ADDENDUM NO. 01 June 24, 2025

To Drawings and Specifications dated June 10, 2025.

PKG 3A – GPHS New Fieldhouse

Prepared by:	PBK
	11 Greenway Plaza, 22 nd Floor
	Houston, TX 77046-1104
	PBK Project No: 240539

1 FLOOR PLAN DW-100.8

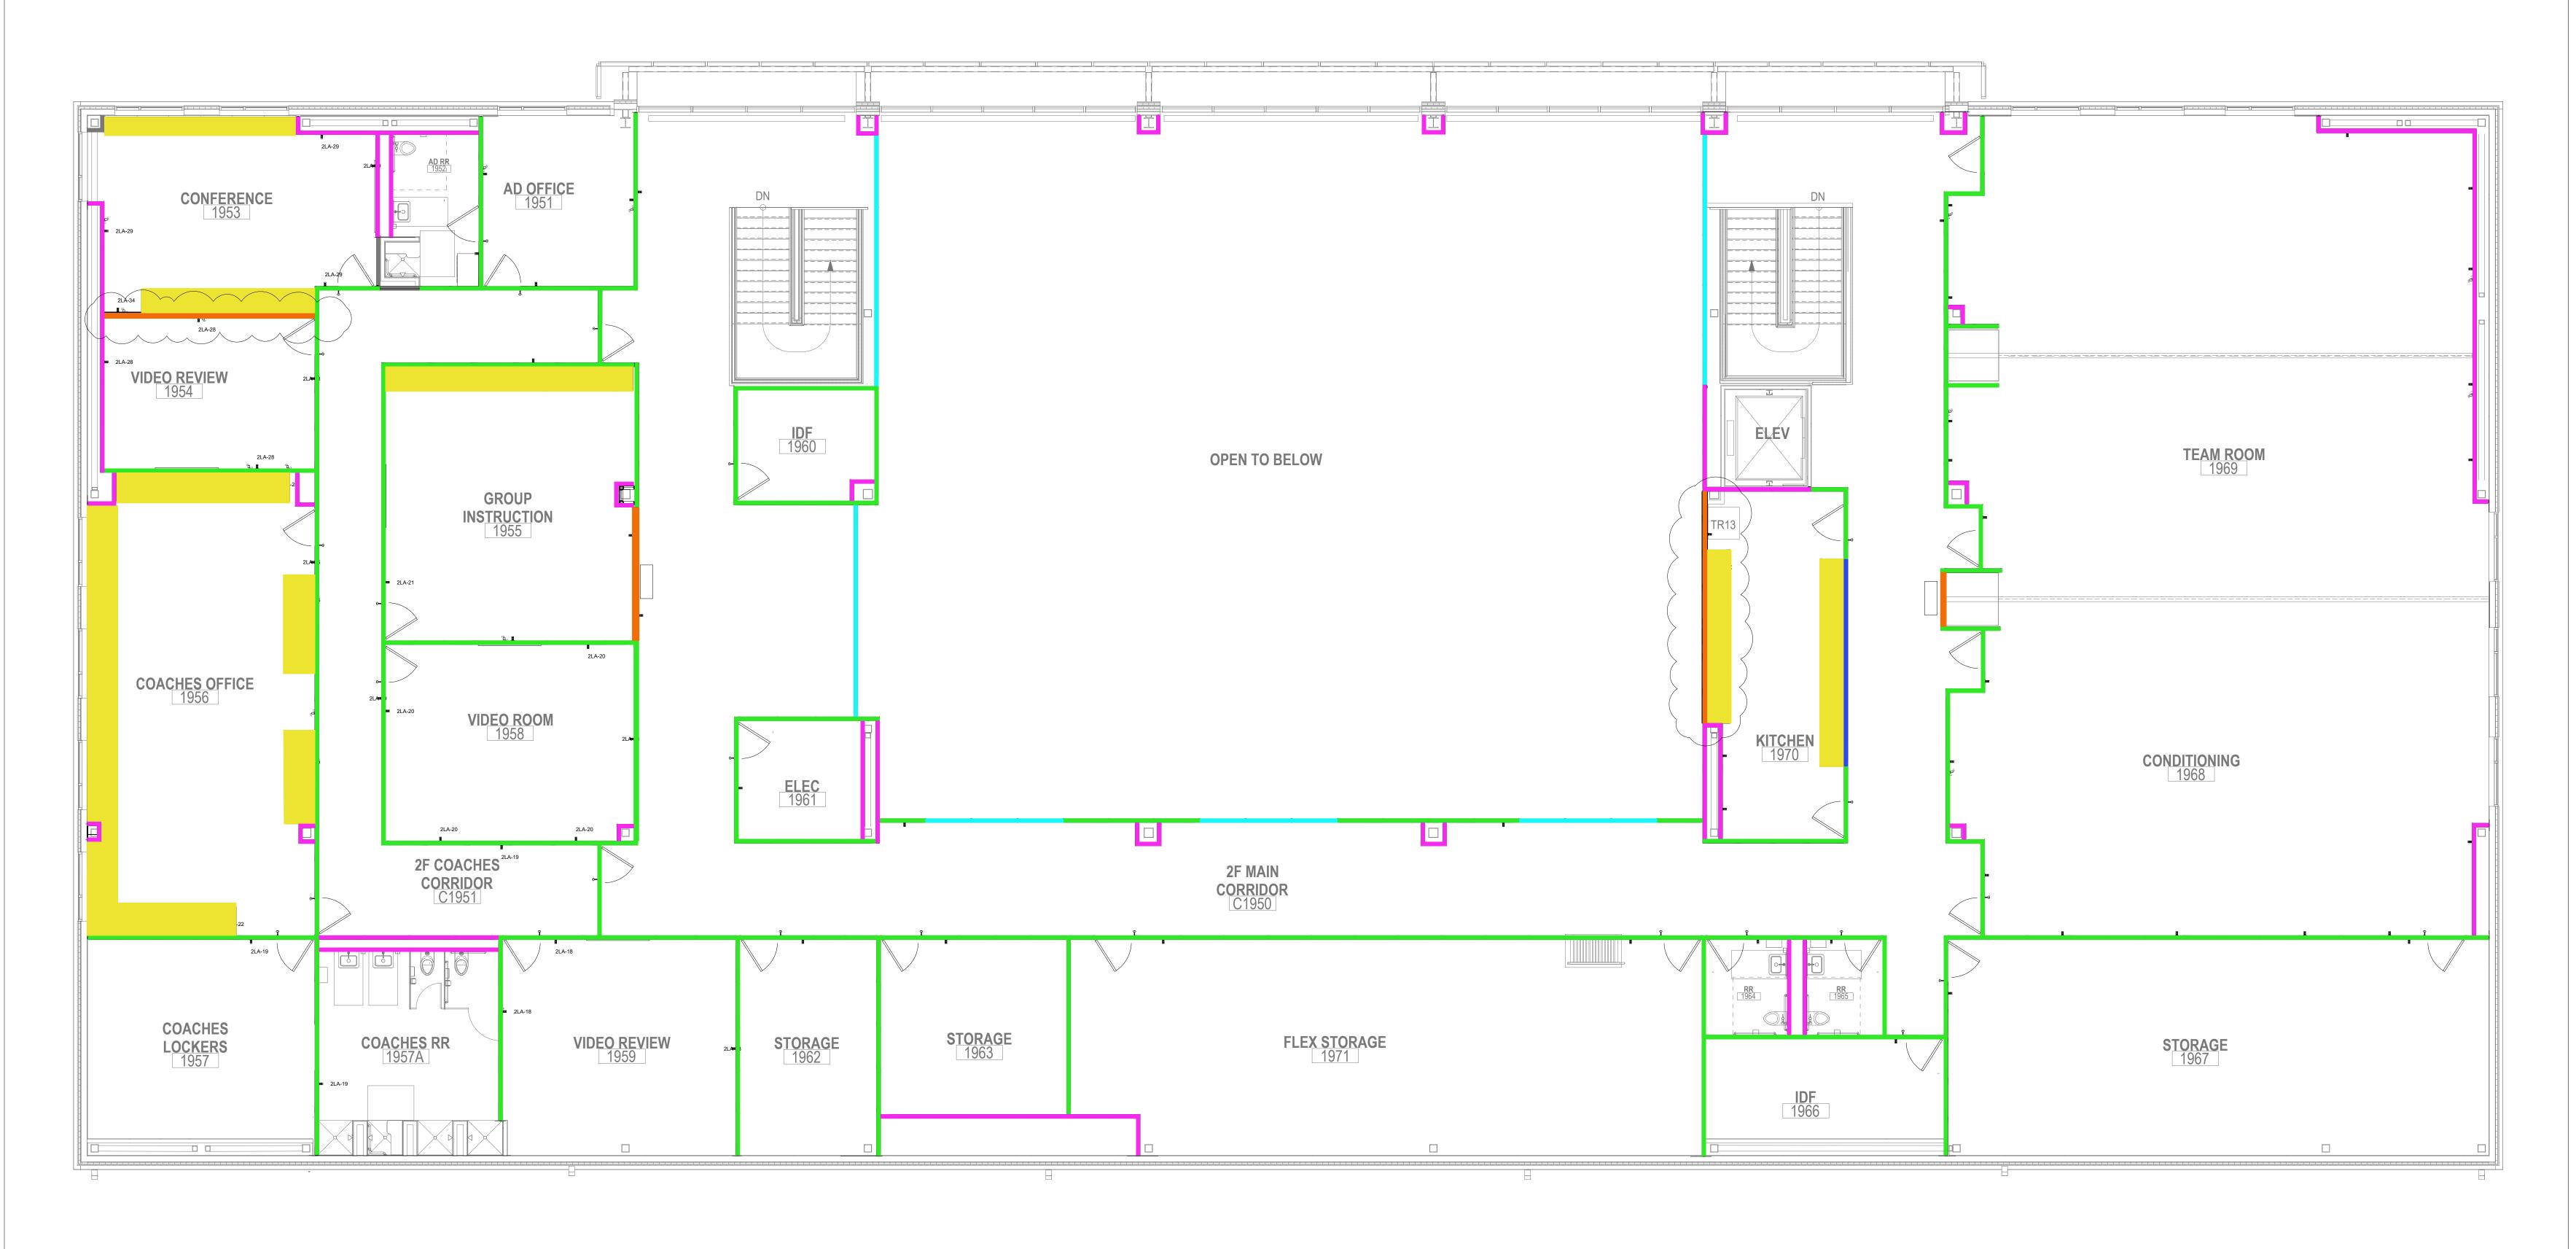
ltem No. 01	DW100.7 HIGHLIGHTED PLAN FIRST FLOOR
А.	DIRTT walls thickness changes from 4" to 6" thick
ltem No. 02	DW100.8 HIGHLIGHTED PLAN SECOND FLOOR
А.	DIRTT walls thickness changes from 4" to 6" thick
ltem No. 03	DW400.1 TYPICAL WALL DETAILS
А.	Typical wall section for 4" and 6" DIRTT walls were added

OVERALL SITE PLAN

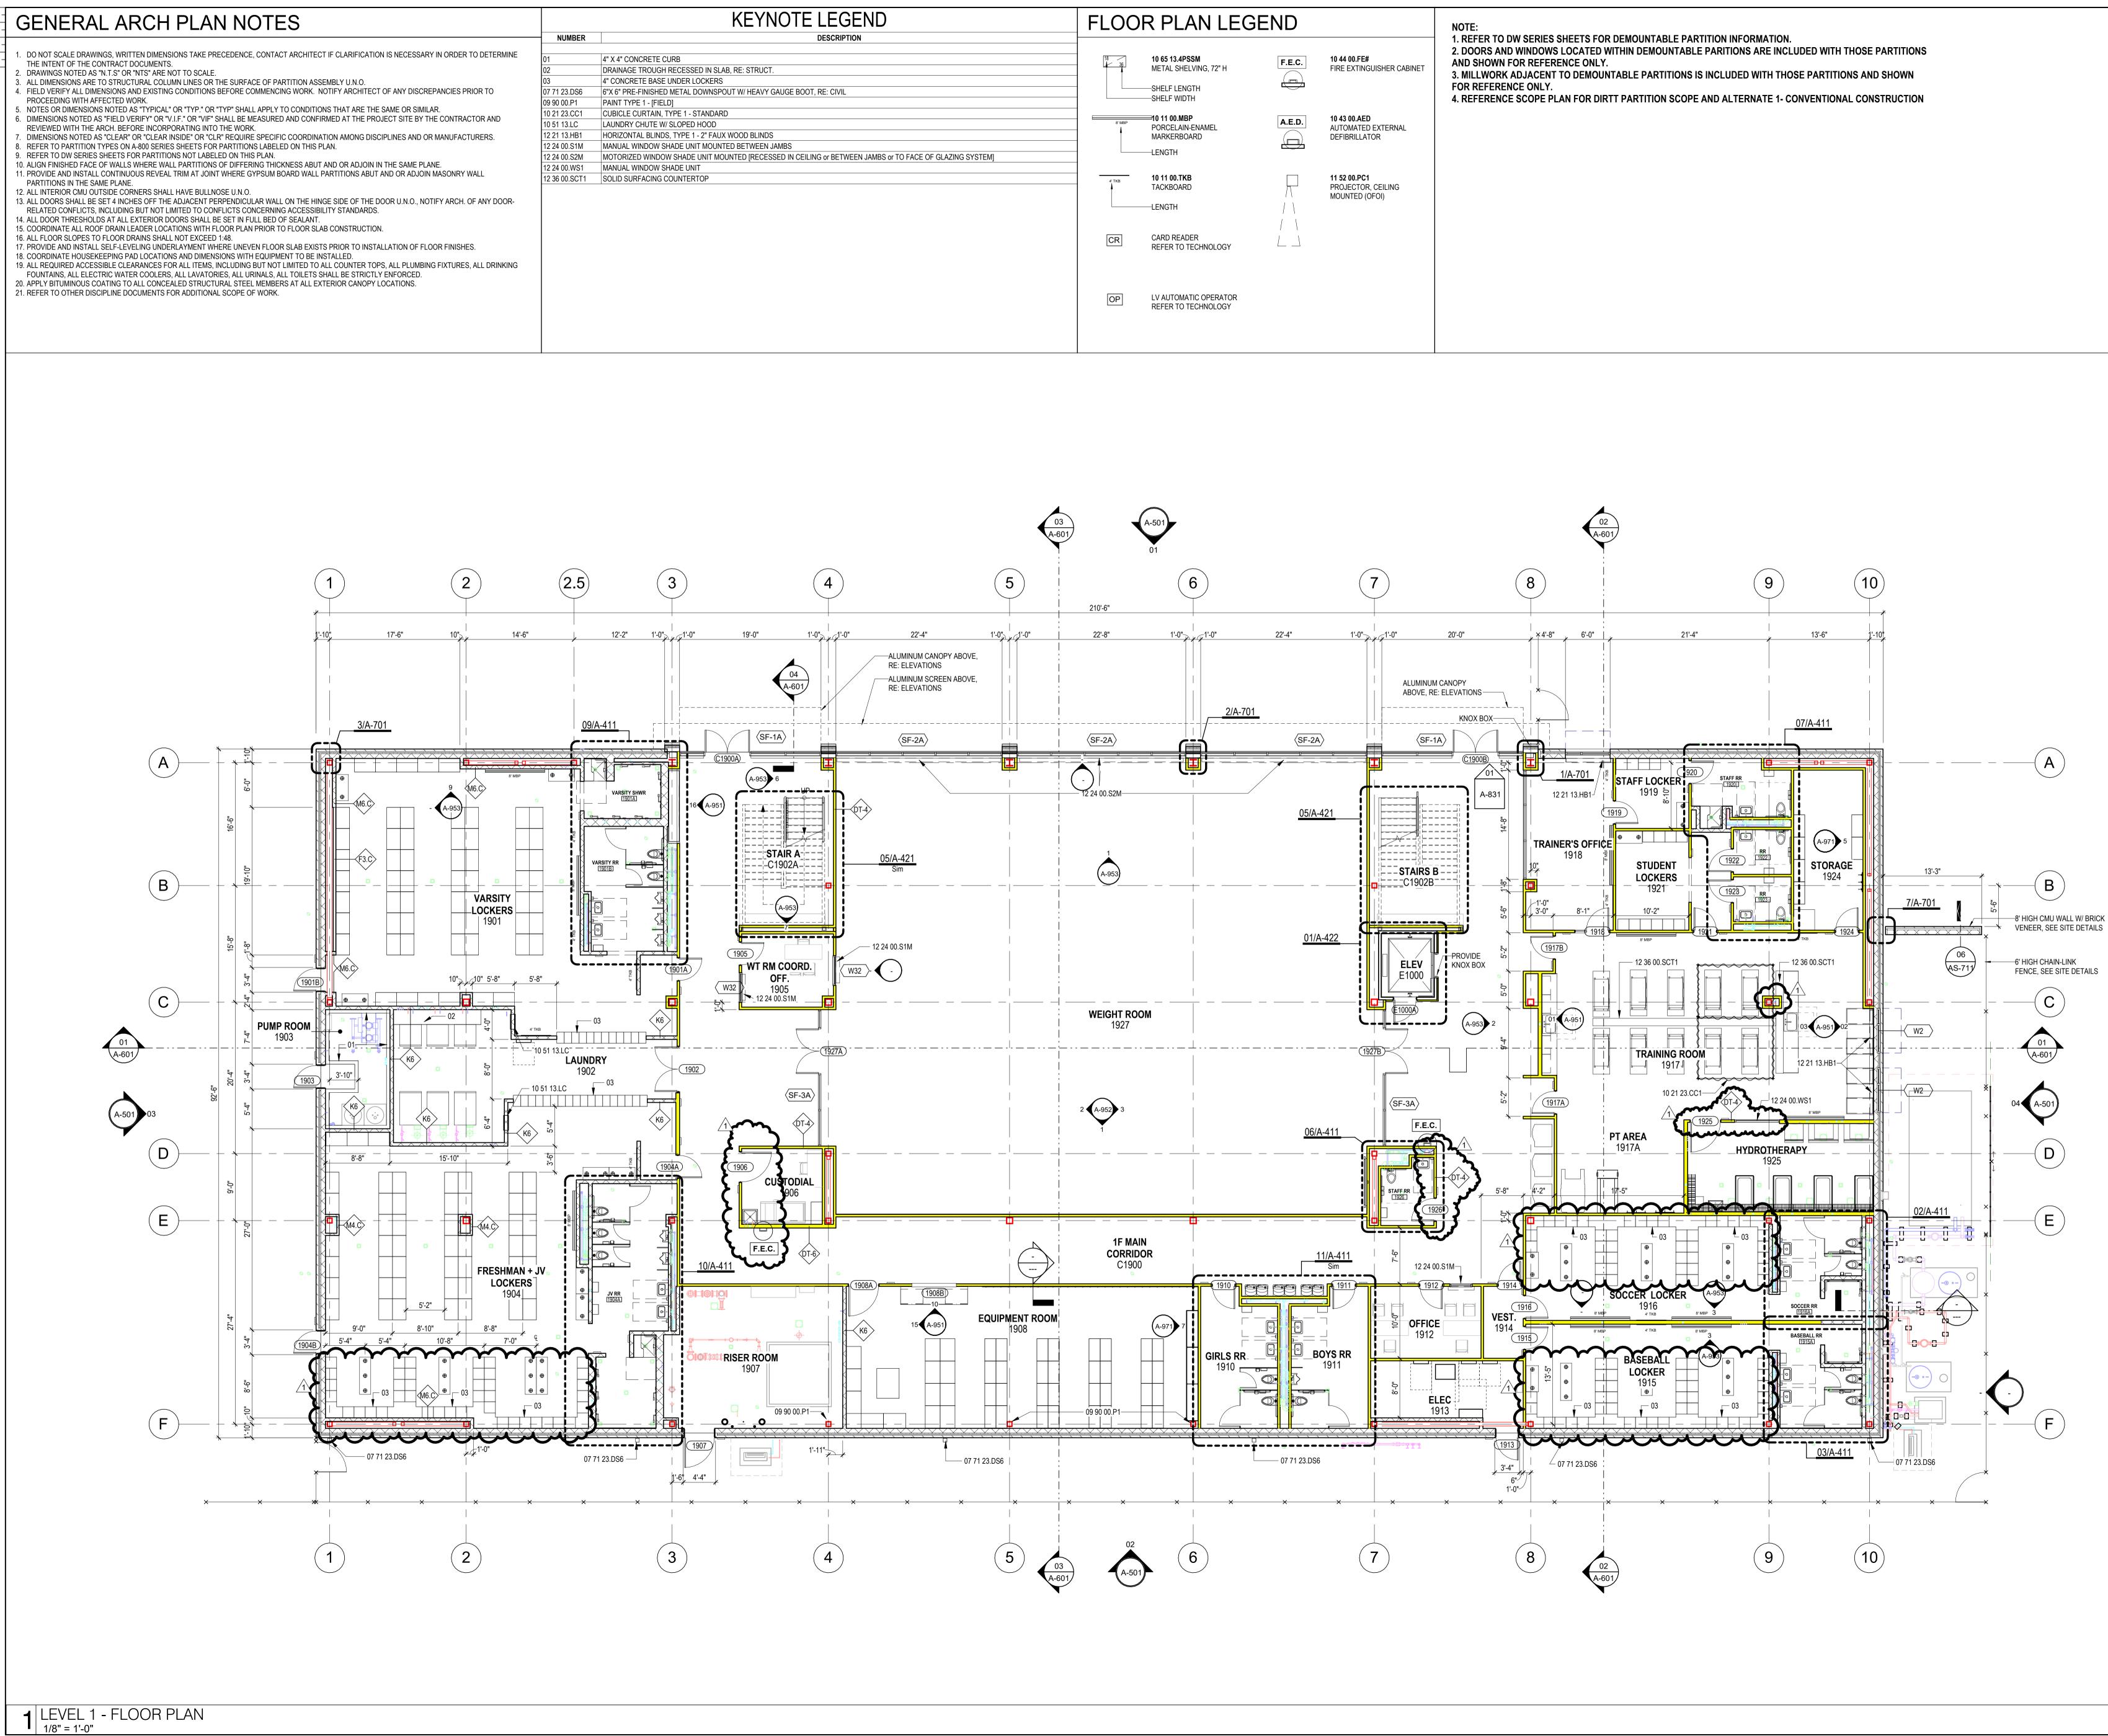
Item No. 02 AS-100 OVERALL SITE PLAN

- A. Added mow strip at new fence at the north side of the site by the existing field house
- B. Added note to demolish portion of existing sidewalk and replace with sod
- C. Reversed the swing direction of gate 1908F
- D. Extended the new sidewalk on the south side out to the existing fence
- E. Added curb cuts at relocated gate
- F. Revised the radius of the fire lane and provided dimensions
- G. Miscellaneous graphic cleanup (not clouded)
